X-TYPE

XT501-20

TECHNICAL BULLETIN

Luggage Compartment Lid Not
Opening Correctly – Spring Actuators –
Install Revised Parts

ILLUSTRATION 1

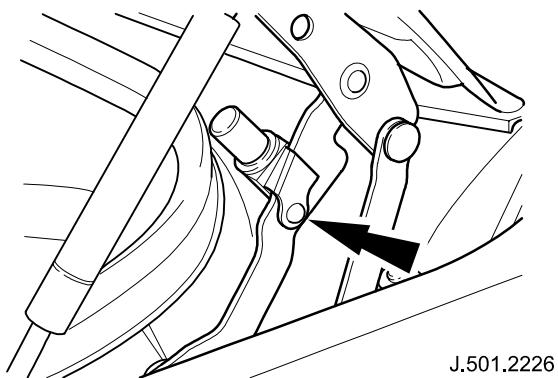
1. Open luggage compartment lid and install fender protector covers.
2. Displace the plastic pushpin from the first spring actuator securing rivet, if installed (see Illustration 1).

3. Remove and retain the securing plastic rivet from spring actuator, if installed.
4. Remove spring actuator from luggage compartment lid hinge.
5. Install and align new spring actuator to luggage compartment hinge.
7. If previously removed install original plastic rivet to spring actuator.
8. Insert pushpin into plastic rivet, if installed.
9. Repeat steps 2 to 8 on second spring actuator.
10. Remove fender protector covers and close luggage compartment lid.
